PLANNING COMMITTEE  
Thursday 4<sup>th</sup> April 2024

**- ADDENDUM TO AGENDA -**

**ITEM 5.1: 21/01753/FUL – 26 to 52 Whytecliffe Road South and Purley Station Car Park**

*Fig A2 – Location of windows serving room R1/21*

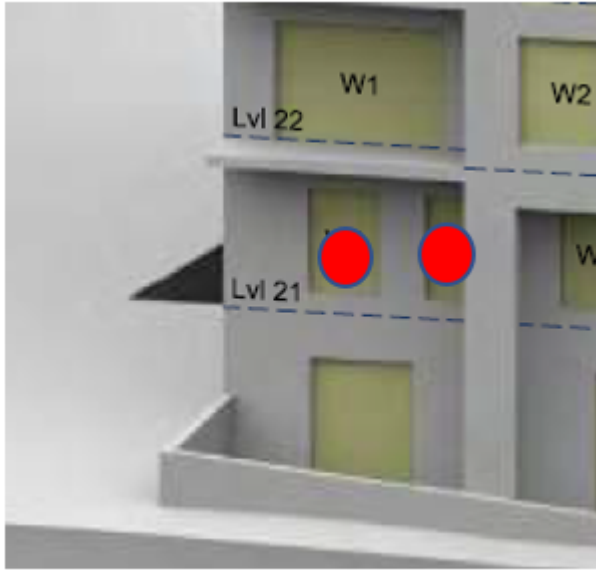
For completeness, it should be noted that the proposed development's impact on 51 to 53 Whytecliffe Road South in terms of No Sky Line (NSL) would also not meet BRE guidance. As in the VSC, there would be substantial failings.

Focusing on the living kitchen dining rooms located at ground and first floor level highlighted previously in figure 30, the NSL reduction is shown below, where four of five previous rooms would retain over 0.8 of its former value, with failure being Room R1/21 which would receive 0.25 of its former value.
